## HISTORIC AND DESIGN REVIEW COMMISSION

**HDRC CASE NO:** 2021-270  
**ADDRESS:** 206 PALO BLANCO ST  
**LEGAL DESCRIPTION:** NCB 6516 BLK 5 LOT 16 & W 20 FT OF 17  
**ZONING:** R-4, H  
**CITY COUNCIL DIST.:** 3  
**DISTRICT:** Mission Historic District  
**APPLICANT:** Lesley Wreyford/Independent Executor estate of JN Workman  
**OWNER:** Lesley Wreyford/WORKMAN JERALD N estate  
**TYPE OF WORK:** Addition, landscaping, fencing  
**APPLICATION RECEIVED:** May 26, 2021  
**60-DAY REVIEW:** Not applicable due to City Council Emergency Orders  
**CASE MANAGER:** Edward Hall

The applicant is requesting a Certificate of Appropriateness for approval to:

FLOOR PLAN

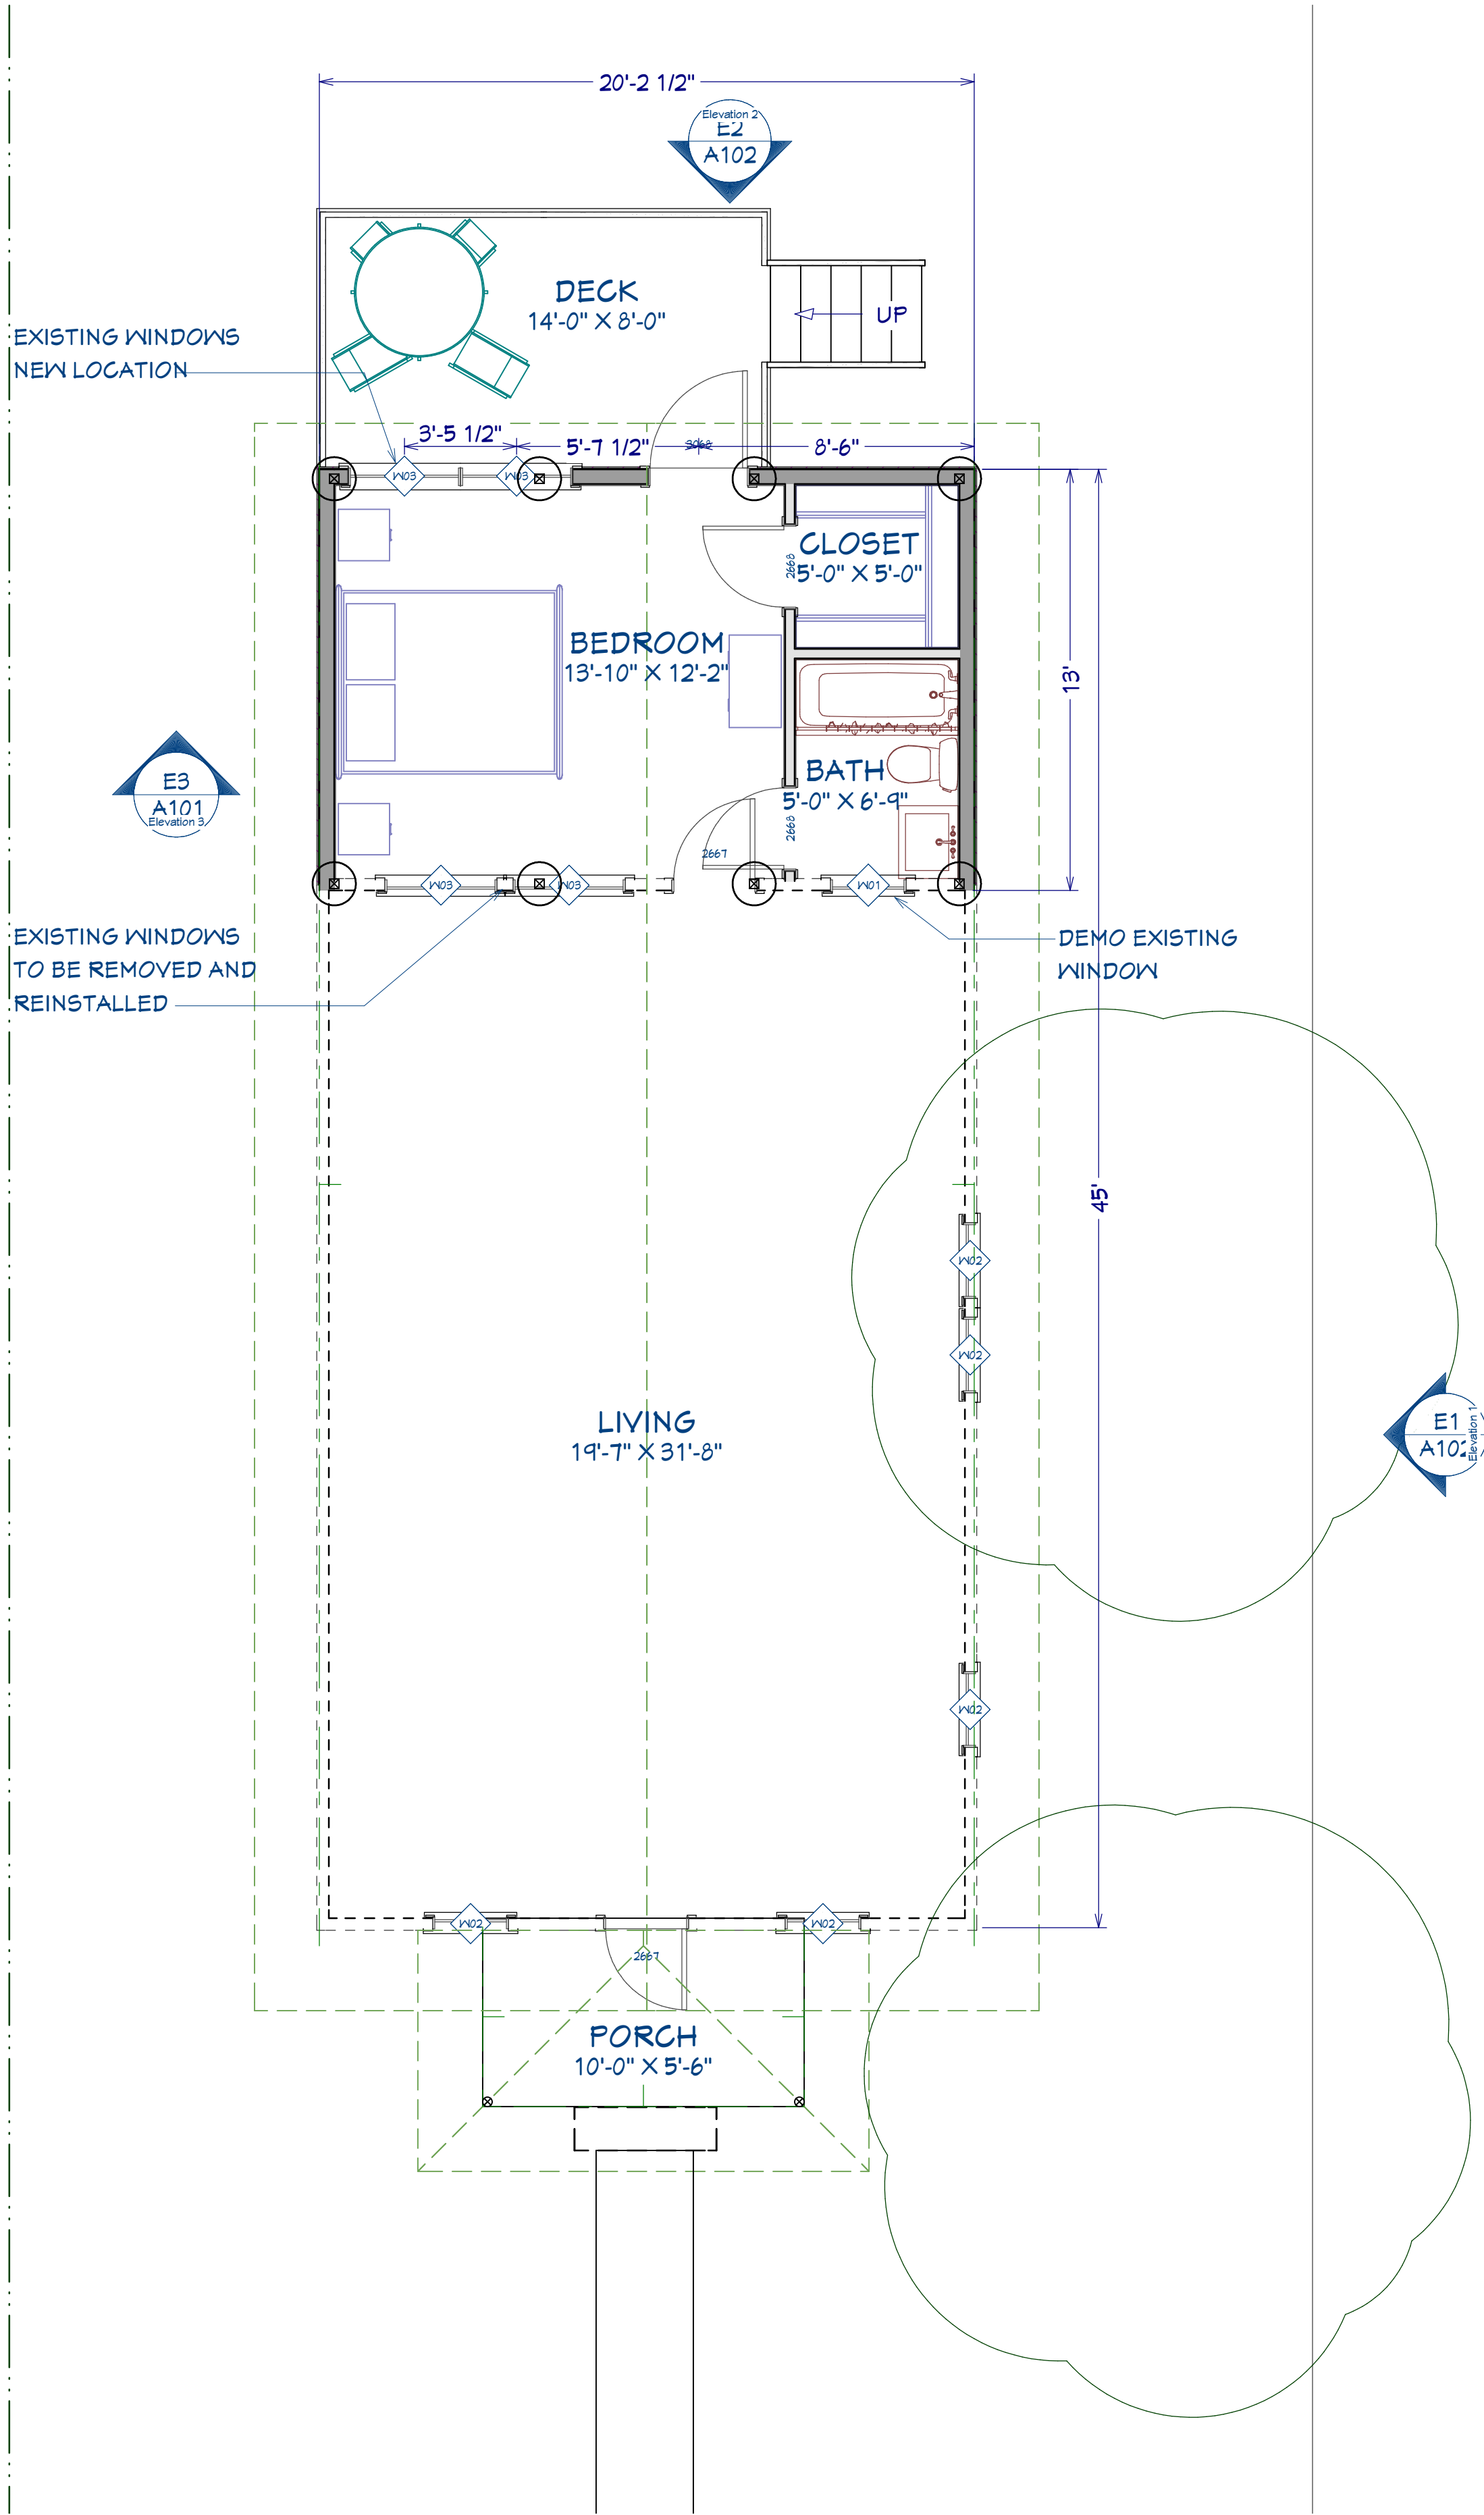
- c. **REAR ADDITION MATERIALS** – The Guidelines for Additions note that additions should feature similar architectural details and materials as the historic structure. Staff finds the standing seam metal roof to be appropriate; however, staff finds that the roof should feature smooth panels that are 18 to 21 inches wide, seams that are 1 to 2 inches in height, a crimped ridge seam, and a standard galvalume finish. The board and batten siding should feature boards that are 12 inches wide with battens that are 1.5 inches wide. If composite materials are used, they should feature a smooth finish with no faux wood grain.

- i. That the standing seam metal roof feature smooth panels that are 18 to 21 inches wide, seams that are 1 to 2 inches in height, a crimped ridge seam, and a standard galvalume finish. The board and batten siding should feature boards that are 12 inches wide with battens that are 1.5 inches wide. If composite materials are used, they should feature a smooth finish with no faux wood grain.
- ii. That the existing windows on the rear façade be reinstalled in a manner that is consistent with that found historically on the structure.
- iii. That the rear privacy fence not exceed six (6) feet in height.
- iv. That the existing, rear door and half sized windows on the rear elevation be salvaged, if possible.

**WEST ELEVATION**  
SCALE: 1/2"= 1'-0"

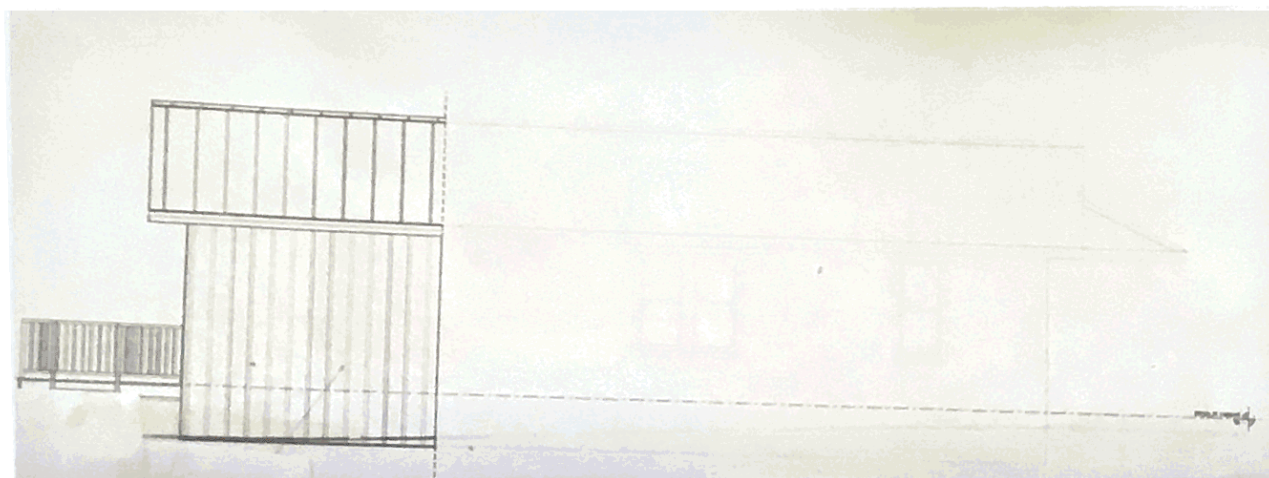
- d. **REAR ADDITION (Fenestration and window materials)** – Generally, the applicant has proposed an addition that results in expanses of side elevations that are void of fenestration. Staff finds that additional fenestration should be added to the right and left elevations as this will be visible from the right of way at the sidewalk and street. Regarding window materials, the applicant has noted the reuse of existing windows on the rear façade. Staff finds that windows that are grouped should be separated by a mullion of approximately six (6) inches in width, as found on the historic structure.

FLOORPLAN &  
ELEVATIONS

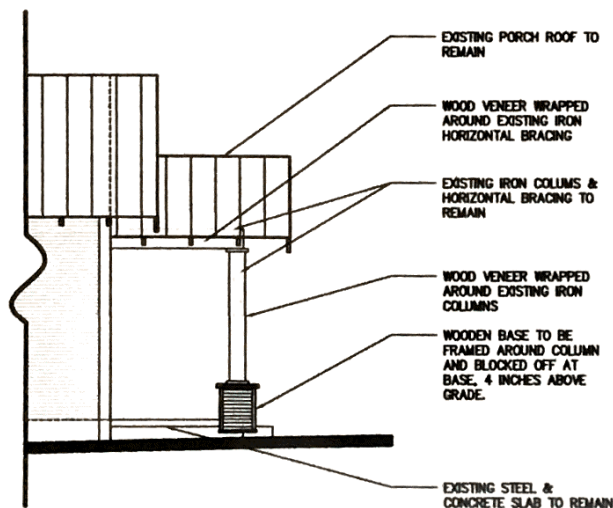
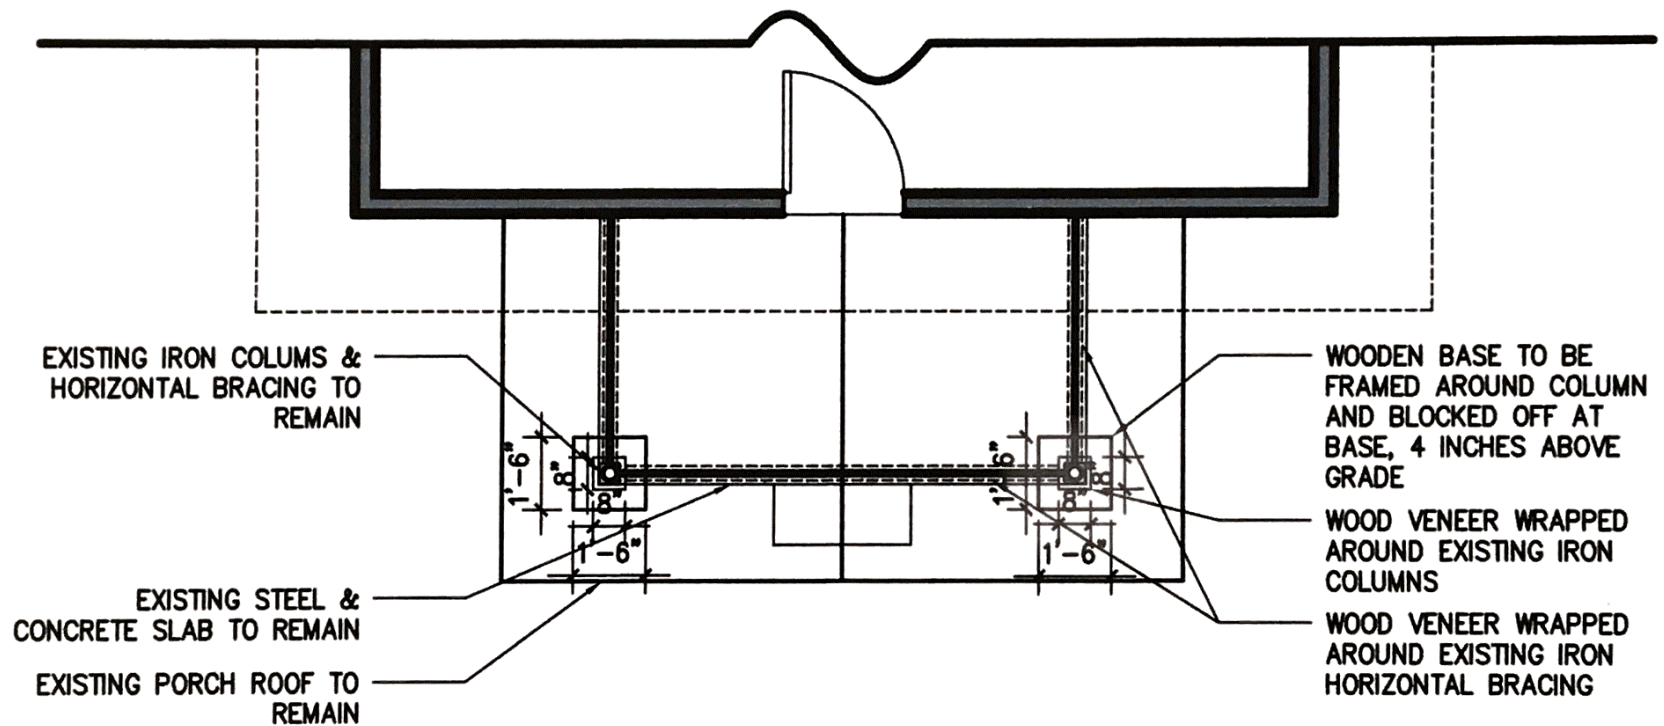
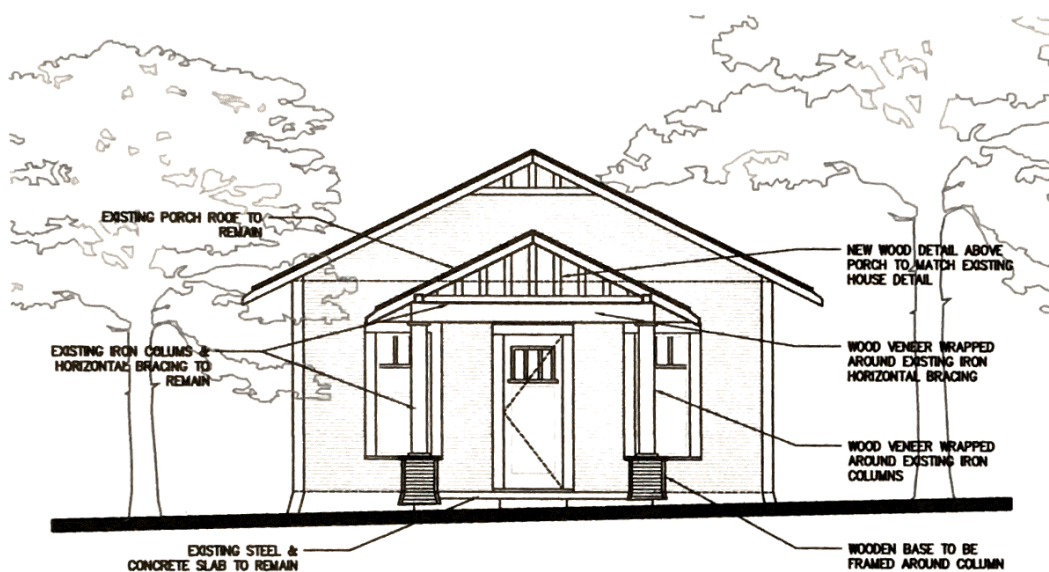
- g. **PORCH RECONSTRUCTION** – The applicant has proposed to front porch, including columns and porch roof profile. The existing, concrete porch will remain. Generally, staff finds the proposed reconstruction to be appropriate.
